# Recall Bulletin

## F/CMVSS NONCOMPLIANCE RECALL

**SUBJECT:** Floor Console Armrest Latch

**MODELS:** 2016 Chevrolet Colorado  
2016 GMC Canyon

3710733

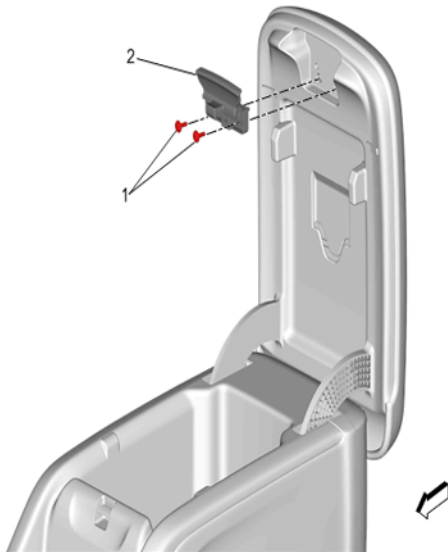
1. Replace the front floor console compartment door latch (2). Refer to *Front Floor Console Compartment Door Latch Replacement* in SI.
